**CITY OF CARMEL-BY-THE-SEA
PLANNING COMMISSION
REGULAR MEETING AGENDA**

August 13, 2014
Wednesday
Tour – 2:00 p.m.
Meeting – 4:00 p.m.

Planning Commission Report

PROPOSED SITE PLAN

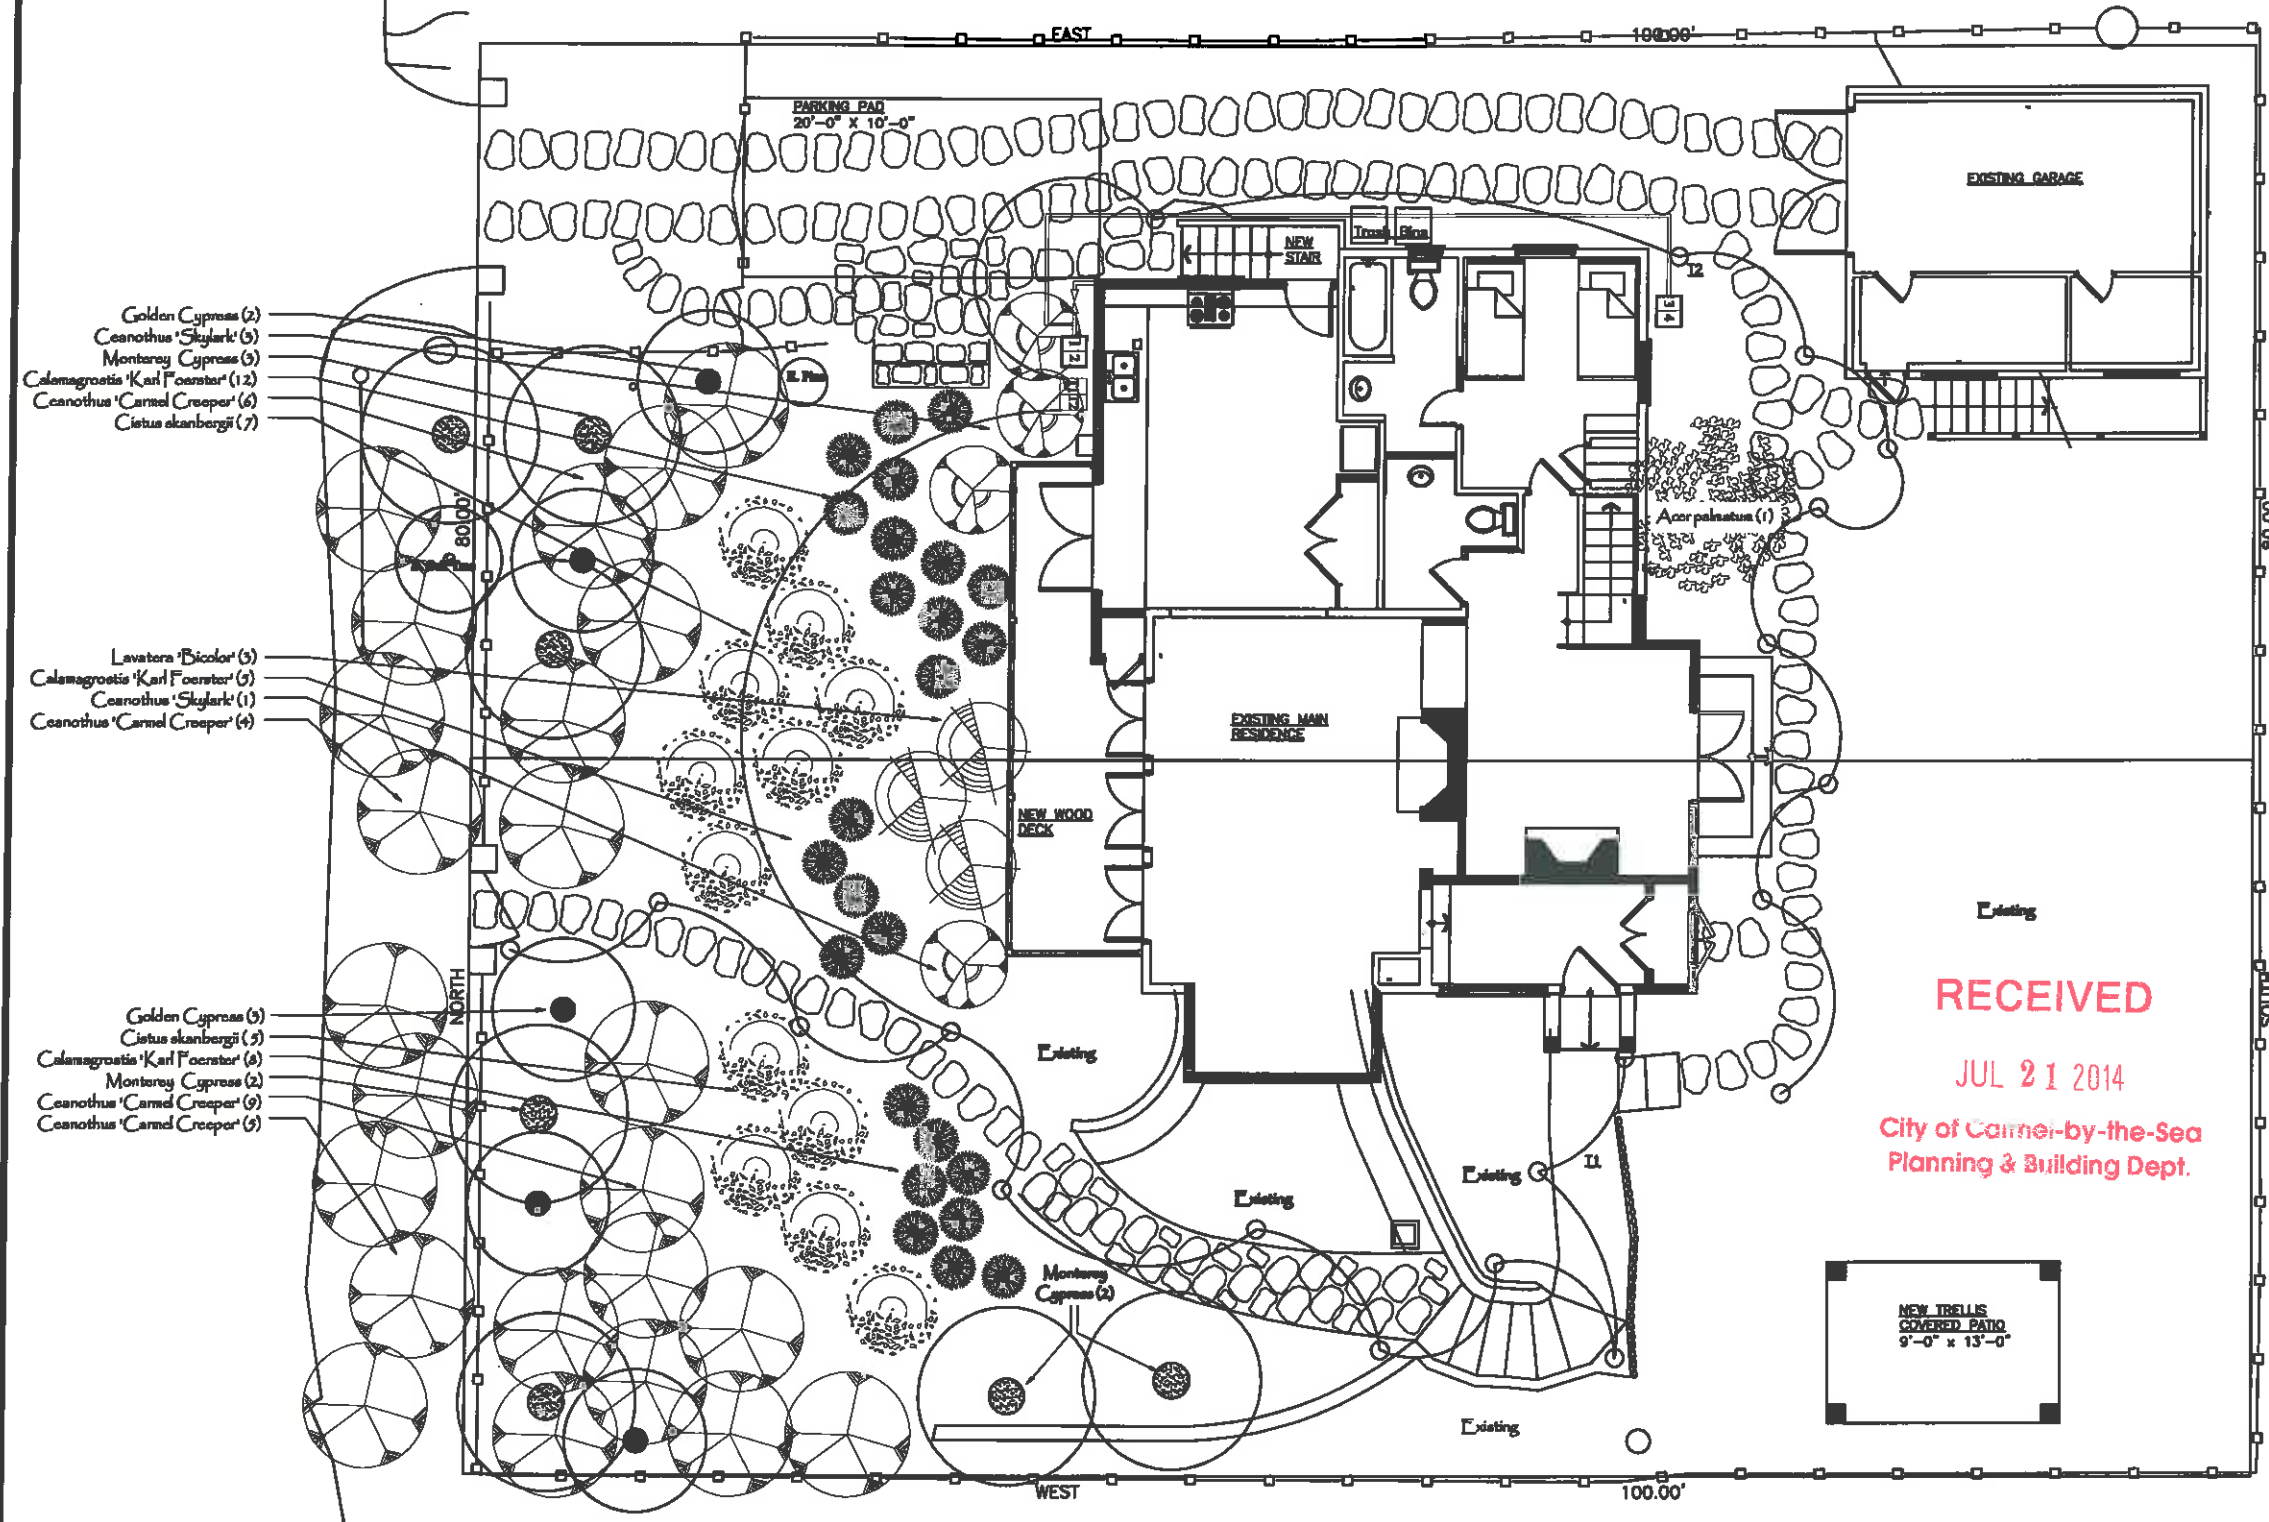
The property owner recently planted several new upper canopy trees, including six Monterey cypress trees and five golden cypress trees at the front of the property, as depicted on the landscape plan on Sheet L-2 of the plan set. Staff supports new upper-canopy trees being planted on the property, but notes that the trees were planted without approval of a landscape plan by the City. A condition has been drafted requiring the applicant to work with Planning staff and the City Forester on obtaining an approved landscape plan prior to the issuance of the Building Permit. The City Forester may recommend that some of the trees be removed or relocated to ensure the future health of the trees.
